GOVERNMENT OF THE DISTRICT OF COLUMBIA
STATE HISTORIC PRESERVATION OFFICER

RE: Final Determination of Effect for the Eisenhower Memorial per Stipulation 11 of the 2012
Memorandum of Agreement

FINAL EISENHOWER MEMORIAL DESIGN

APRIL 2015 DESIGN: AERIAL VIEW

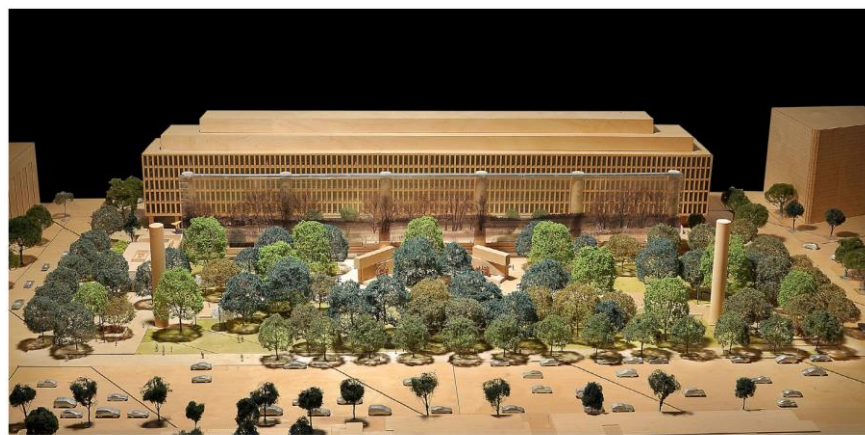
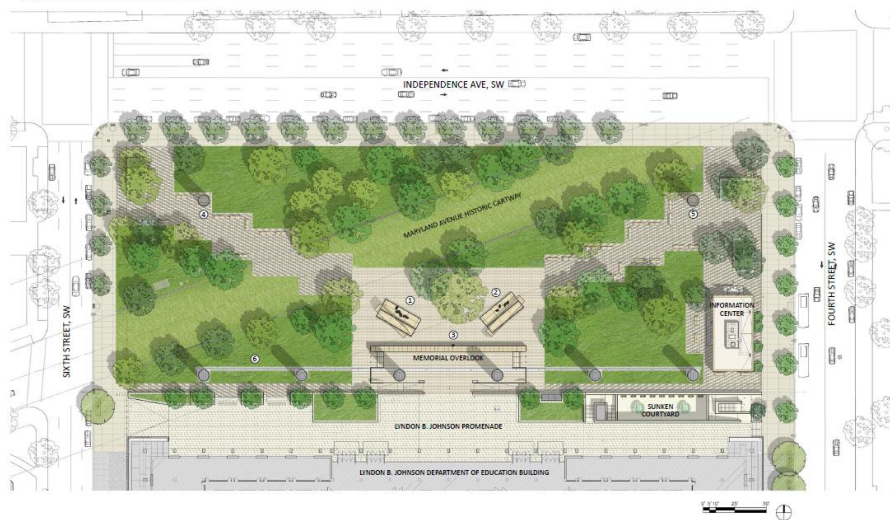
After carefully evaluating the illustrations that were forwarded along with the May 8th letter to document the proposed final Eisenhower Memorial design (attached for reference), and in consideration of the fact that the design has clearly been revised to avoid and minimize adverse effects in response to Section 106 consultation, we also concur with the NPS determination that no new or intensified adverse effects on historic properties will occur as a result of the final design.
